### AMENDMENTS TO THE DRAWINGS

## REMARKS/ARGUMENTS

Appl. No. 10/046,066  
Amdt. Dated Oct. 13, 2005  
Reply to Office Action of Jan. 27, 2005  
Annotated Sheet Showing Changes

FIG. 3

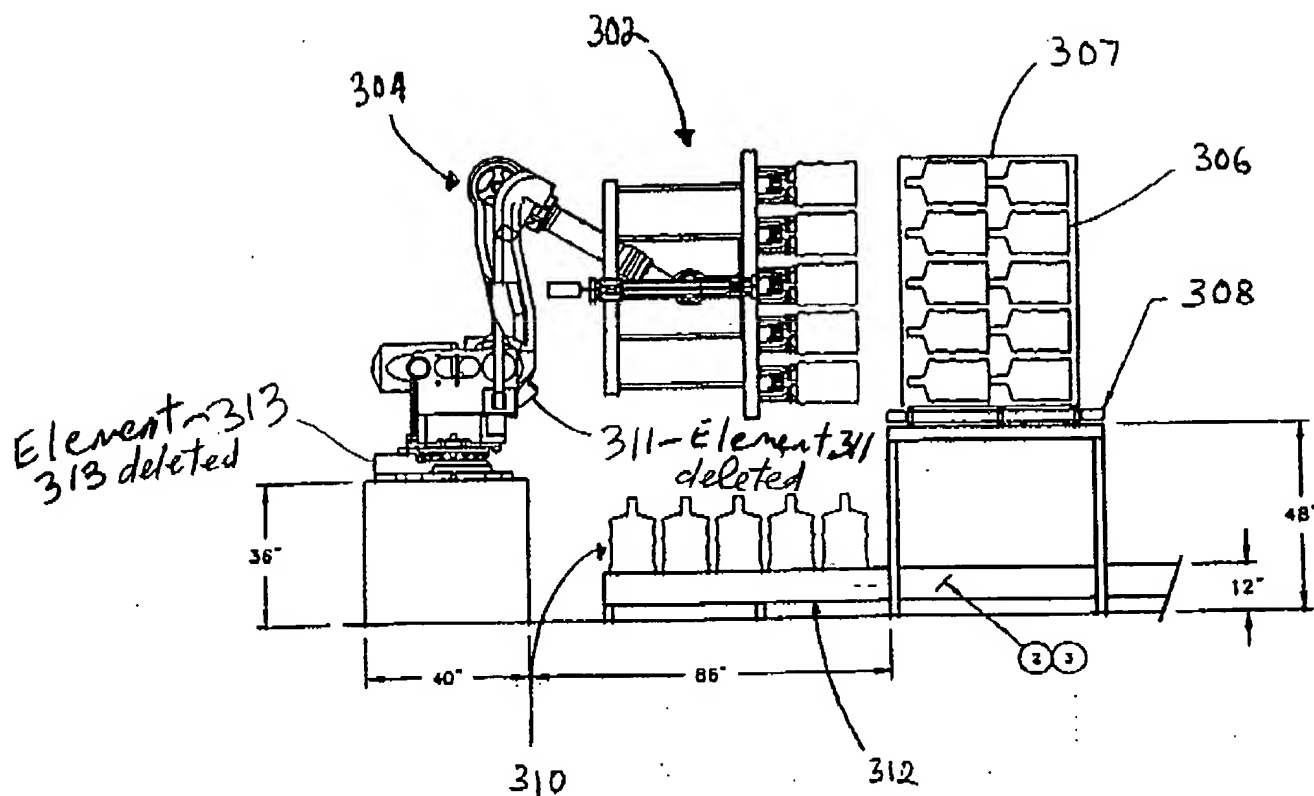
The attached sheets of drawings include changes to Fig. 3. These sheets, which includes Fig. 3, replaces the original sheet including Fig. 3. In amended Figure 3, element numeral 313 and 311 have been deleted. 313 and 311 were previously added to figure 3 to reflect "motorized base" and "interface" in previous presented claims. These claims, however, are now canceled. Further more, "motorized base" was actually referred to drive 222 and 226, and not as identified by 313. And, "interface" is adequately noted in figure 2A, and incorrectly identified by 311.

In amended Figure 3, element numeral 313 and 311 have been deleted. 313 and 311 were previously added to figure 3 to reflect "motorized base" and "interface" in previously presented claims. These claims, however, are now canceled. Furthermore, "motorized base" was already identified by drive 222 and 226. And, "interface" was already identified in figure 2A.
